Additional sealing step in PTFE pumps housing

Starting from serial no. 1510-.... Tapflo introduces additional sealing step in T50 T, TX50 T, T100 T, TX100 T, T200 T, TX200 T, T400 T; TX400 T pumps housings.

Old design of housing

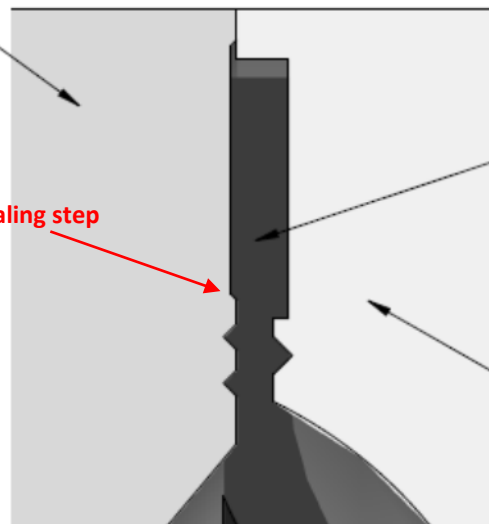
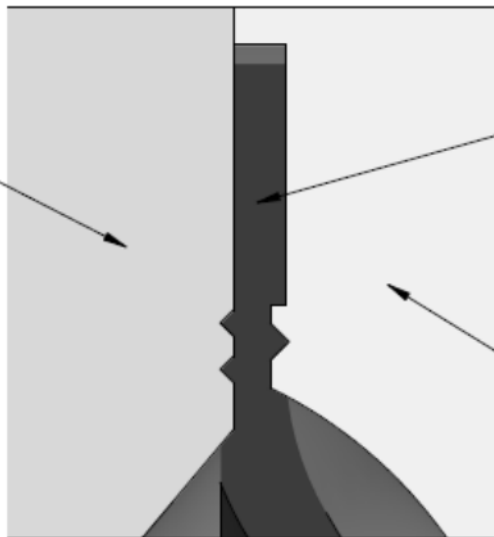
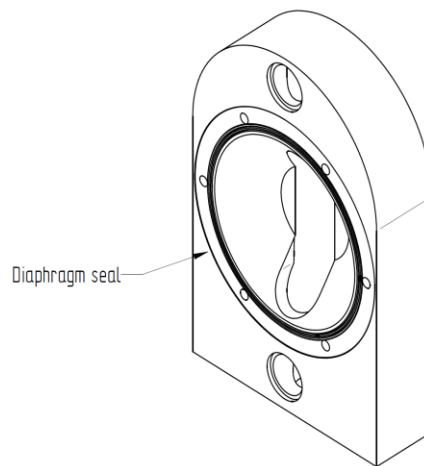
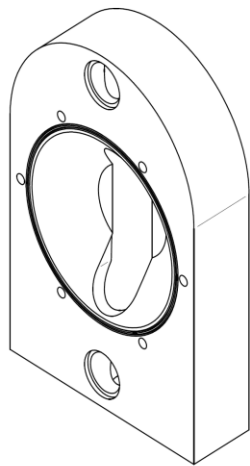
Increased PTFE housings relaxation over the time was observed after pump assembly. As a result, more frequent pump re-tightening is required, when compared with PE housings. To avoid such situation additional step in PTFE housing was introduced.

Additional sealing step provides better seal of diaphragm between pump housing and centerblock,

No other parts besides pump housing will be changed. Old and new design housings are interchangeable. Codes for new type of housings remain the same.
